AGENDA
CITY OF CEDAR FALLS, IOWA
PLANNING AND ZONING COMMISSION MEETING
WEDNESDAY, SEPTEMBER 08, 2021
5:30 PM AT CITY HALL OR VIA VIDEO CONFERENCE

TO: Planning & Zoning Commission
FROM: Thom Weintraut, AICP, Planner III
DATE: August 31, 2021
SUBJECT: Land Use Map Amendment (LU20-04)
 Rezoning Thunder Ridge, West 1st Street and Eagle Ridge Road (RZ20-009)

REQUEST: Amend Future Land Use Map to reflect Community Commercial
 Rezone property from A-1: Agricultural District, C-2: Commercial District, and
 S-1: Shopping Center District to PC-2: Planned Commercial District

Wetlands

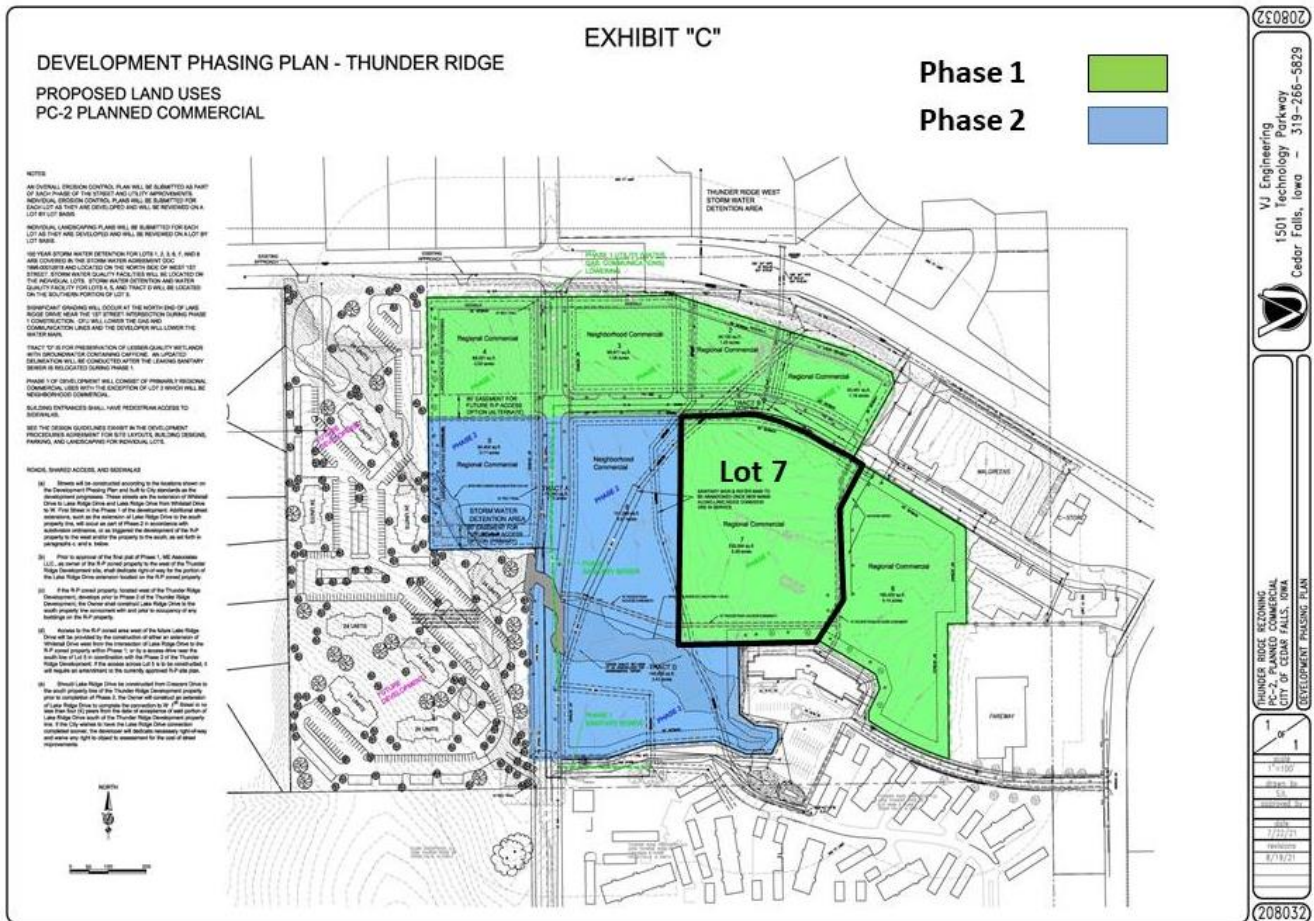
There is an area of identified wetlands on the southern portion of the development site, which will need to be remediated if disturbed. An environmental report will be required with the preliminary plat including a more recent wetland delineation. Prior to any development activity in this area, a definitive wetland mitigation plan will be required and appropriate approvals received by the U.S. Army Corp of Engineers.

THUNDER RIDGE REZONING
 PC-2, PLANNED COMMERCIAL
 CITY OF CEDAR FALLS, IOWA
 DEVELOPMENT PHASING PLAN

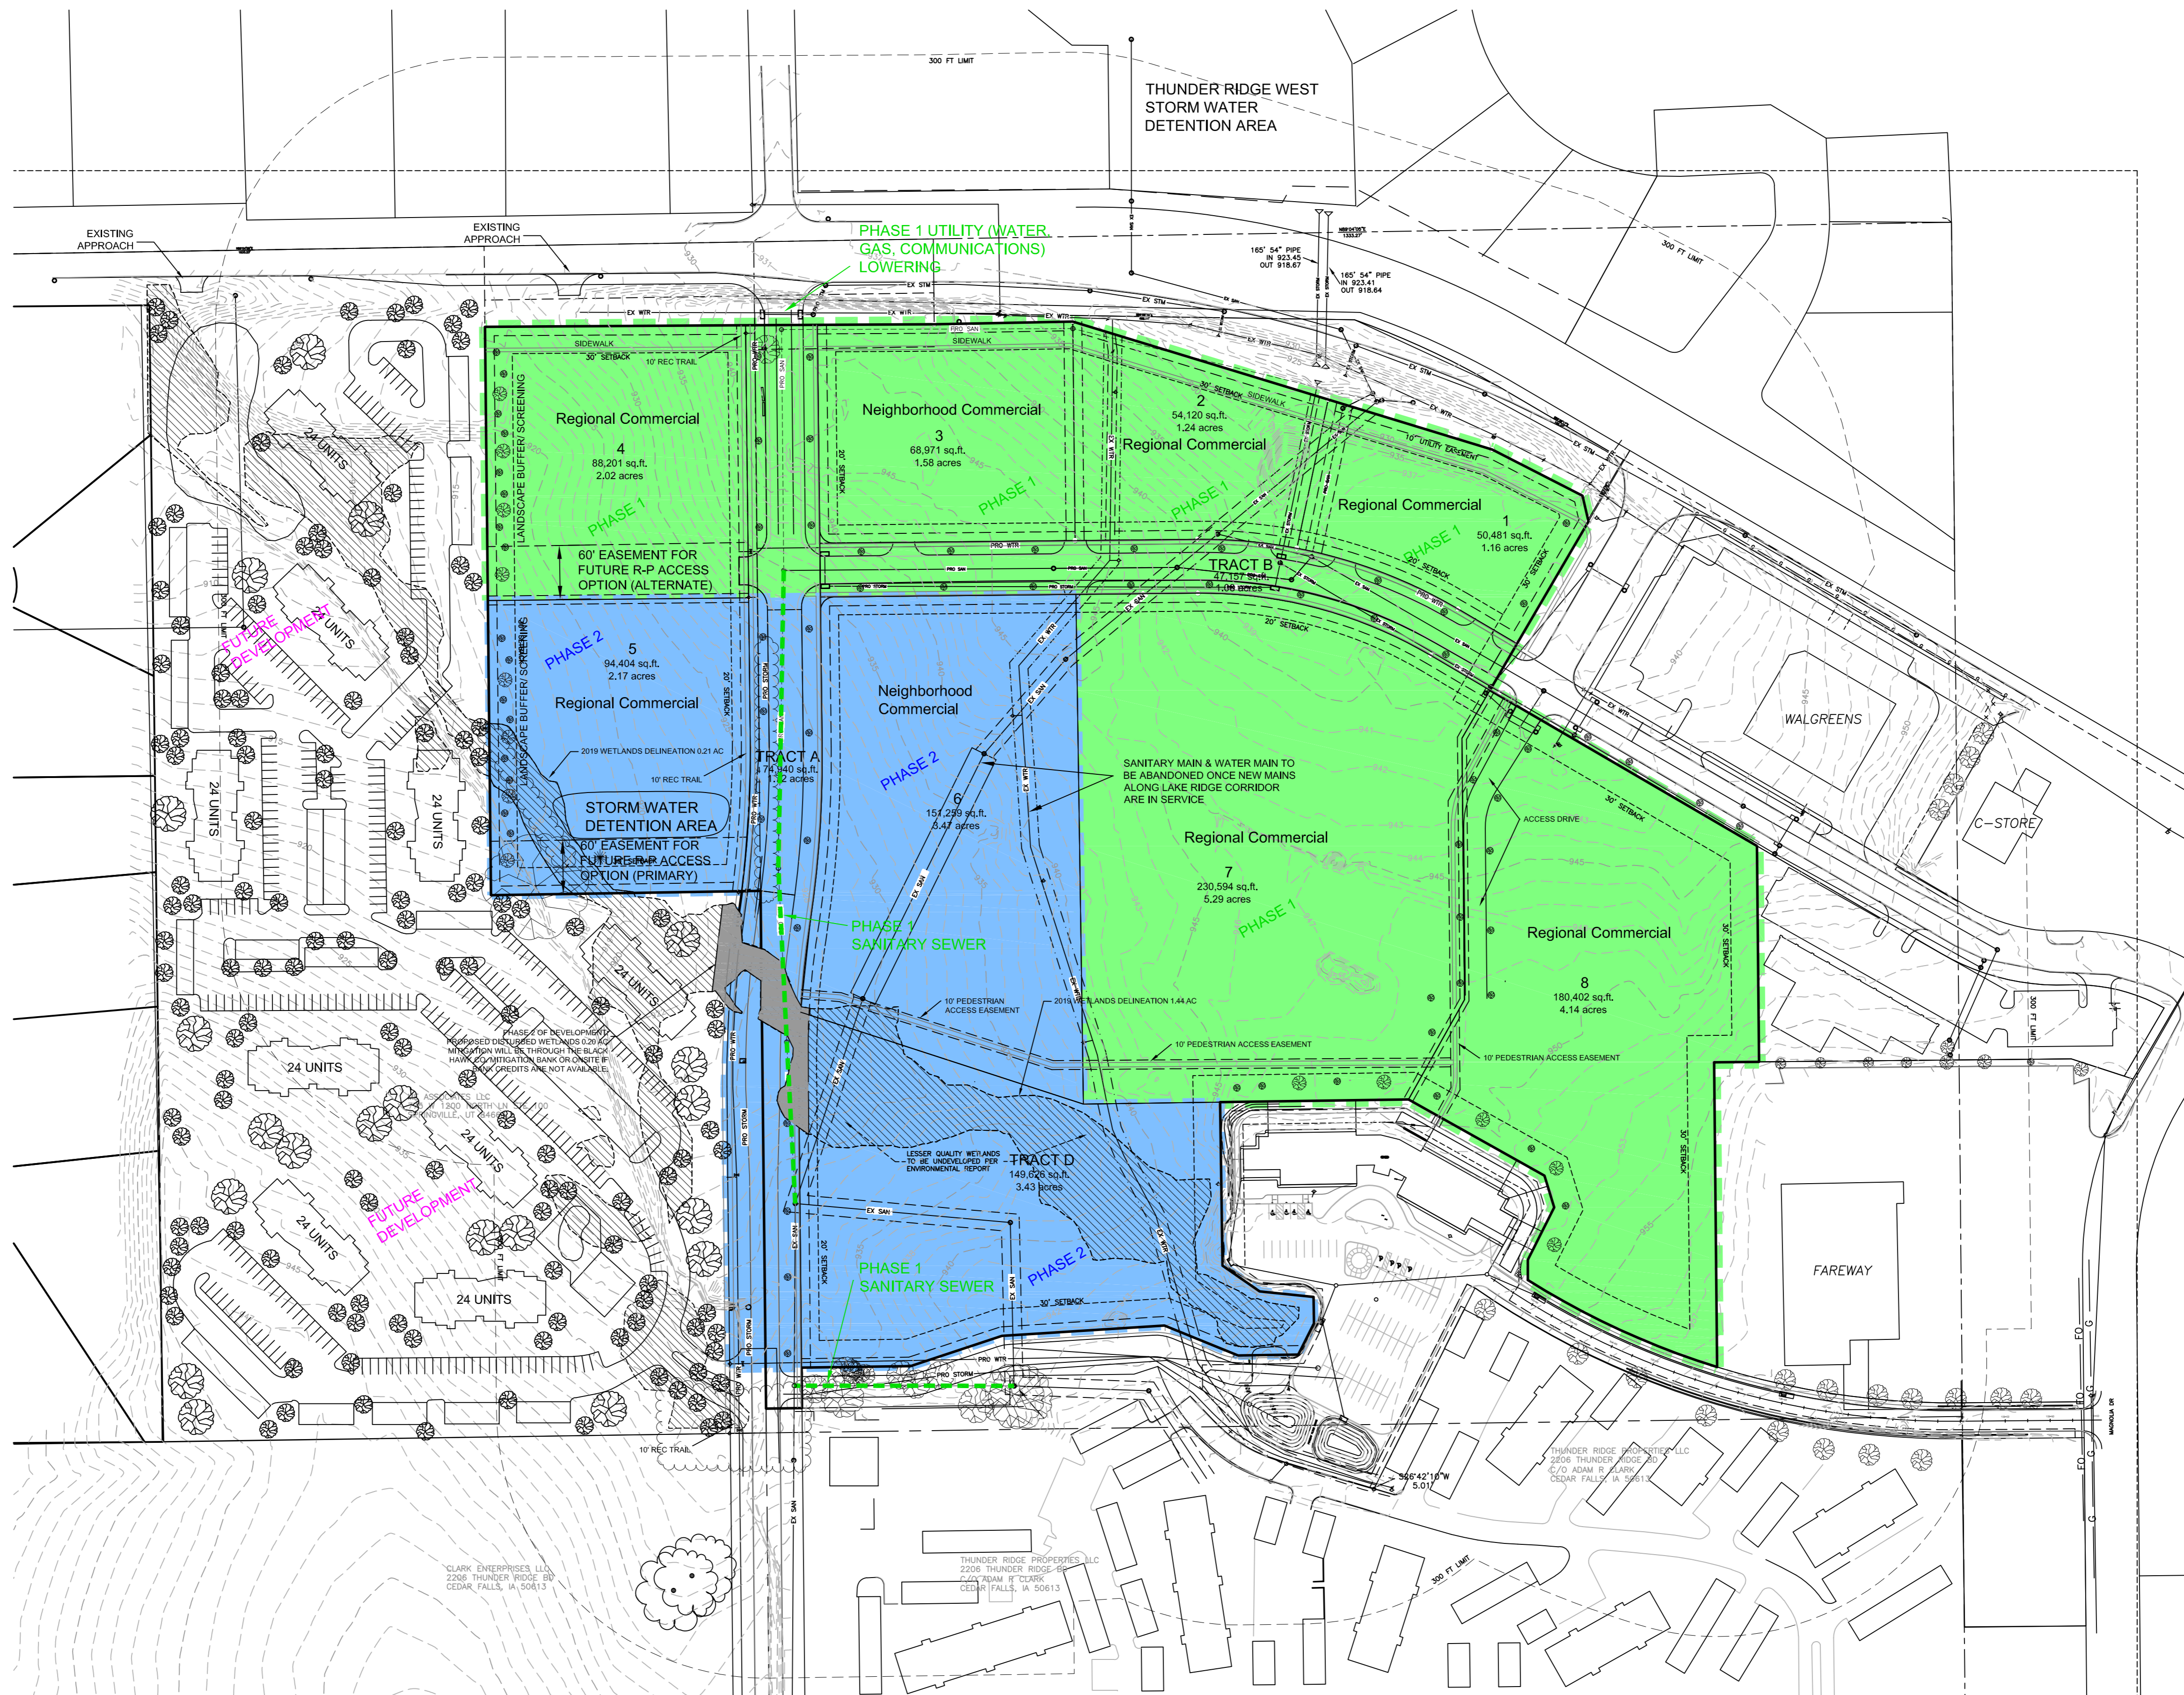
The extension of Lake Ridge Drive is a critical street connection in this area. Consideration should be given to how the adjoining neighborhoods have access to the site. Currently the options for the residents of the neighborhoods to the south to access the proposed development are limited. Magnolia Drive and Highland Drive are the only north-south connection to W 1st Street between Hudson and Union Roads. The development of Thunder Ridge and Lake Ridge Drive is one of few opportunities to provide a north-south connection.

- Amending the phasing plan to allow only five (5) lots to be platted as part of Phase 1 and including lot 7, the medical/office lot, with Phase 2, creating more incentive to complete this street connection.
- Amending the phasing plan so that the extension of Lake Ridge Drive occurs in the 1st Phase.
- See other possible solution in the report summary below for payment of fees to the City for constructing the road on a per acre basis as plats are approved.

2. The development phasing plan does not meet the subdivision requirement to ensure timely connections of critical infrastructure. In this case, the extension of Lake Ridge Drive. Staff does not recommend approval until the phasing plan is amended to provide more certainty that this critical street will be extended or an alternative approach acceptable to the City is agreed upon.

One remaining issue that has not been fully resolved is the extension of Lake Ridge Drive to the adjacent property to the south. The extension of Lake Ridge Drive is a critical piece of infrastructure needed to provide a north-south connection from the residential neighborhoods south of the property to 1st Street. There are currently no north-south streets between Magnolia Drive and Union Road that provide a connection to the neighborhoods to the south, a distance of more than 1 mile. Existing cul-de-sacs and environmental features will leave few opportunities for a north-south connection other than the extension of Lake Ridge Drive. The staff has concerns with the Lake Ridge Drive extension as part of Phase 2 because of the small percentage of the developable land associated with Phase 2. Phase 1 is comprised of six lots and public right-of-way totaling 16.71 acres, or 61% of the proposed development. Phase 2 has one two lots totaling 5.64 acres (21%) of the development area. The remaining portion of Phase 2, 4.98 acres, is the right-of-way for Lake Ridge Drive and Tract D, which is an environmentally sensitive area to be reserved for open space. With so little revenue producing land included in the 2nd phase, leaving the largest section of Lake Ridge to this phase will create such a cost burden on those lots as to effectively prevent it from developing. It is the purview of the Planning and Zoning Commission to determine if Lake Ridge Drive is a critical piece of infrastructure and make a recommendation accordingly. It is left to the applicant and the City to draft a development agreement for the timing and the installation of the infrastructure.

Staff has concluded that Lake Ridge Drive is a critical piece of infrastructure that will provide access and circulation for this area of the city. Unless this issue is resolved, staff recommends denial of this application for a rezoning. However, there are positive aspects to the proposed development, so staff has offered several solutions to ensure that Lake Ridge Drive is extended:

1. The applicant can amend the development phasing plan to incorporate a greater portion of the development area into Phase 2, as noted in the report above; or

2. The applicant can amend the development phasing plan to include the construction of the entirety of Lake Ridge Drive to the south boundary of the property as part of Phase 1. The improvements to the intersection of Lake Ridge Drive and 1st Street and relocation of the sewer and water lines to the right-of-way of the Lake Ridge Drive are crucial to the initial phase of development and the extension of the street to the south property line could be incorporated into this construction. The extension of Whitetail Drive from Eagle Ridge Road to Lake Ridge Drive could be moved to Phase 2.

3. Additionally, the City has suggested an alternative proposal to the applicant for the construction of the extension. The applicant would prepare the construction plans for the street and provide a cost estimate for the extension of Lake Ridge Drive from Whitetail Drive to the south property line. The entirety of the street right-of-way would be dedicated to the City with the 1st final plat. The developer would then pay a fee to the City for the construction costs for the road extension on a per acre basis for each phase of the development. These costs could be distributed evenly over the entire development of 27.33 acres and funds paid to the City proportionate to the number of acres final platted

THUNDER RIDGE ZONING
PC-2, PLANNED COMMERCIAL
CITY OF CEDAR FALLS, IOWA
LANDSCAPING PLAN

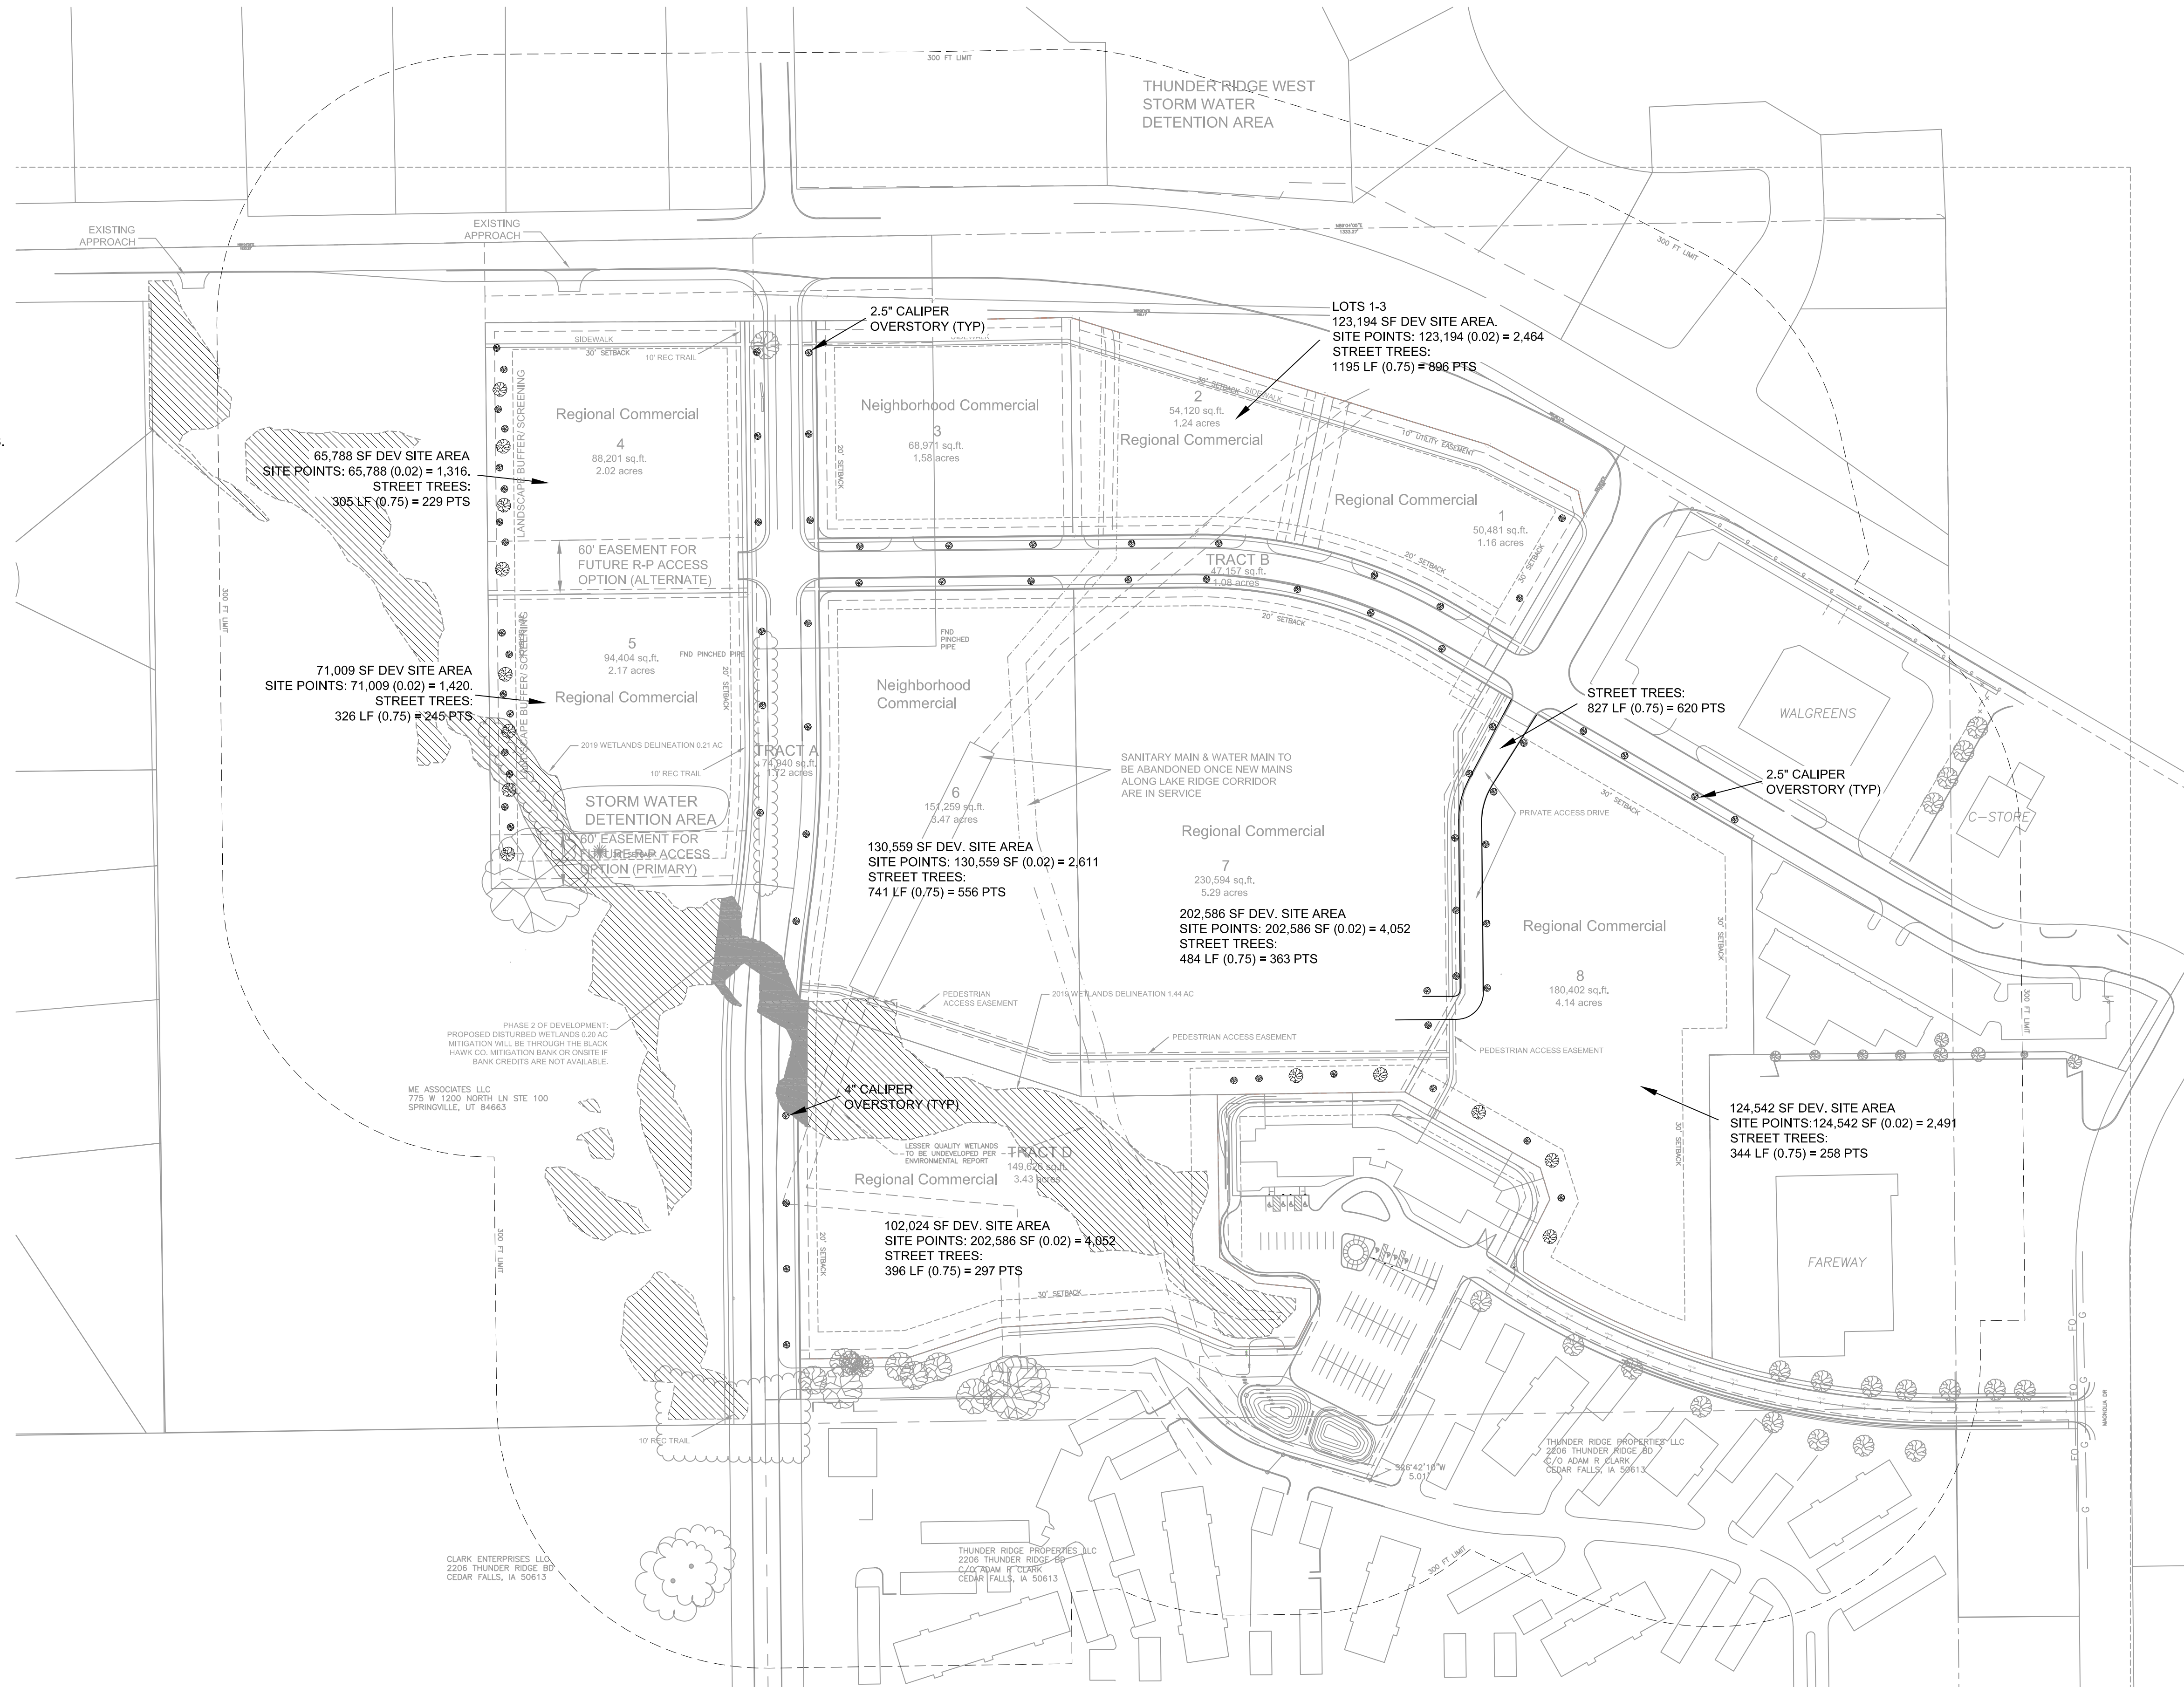
Staff is satisfied the various required documents; Master Development Site Plan, Development Phasing Plan and Landscape Plan are now consistent with the Development Guidelines. In addition, the applicant has submitted an architectural rendering showing a “typical façade” design for smaller buildings with multiple street frontages, i.e. building located along Whitetail Drive which will be visible from 1st Street. These images are shown in the attached Typical Small Building Design.
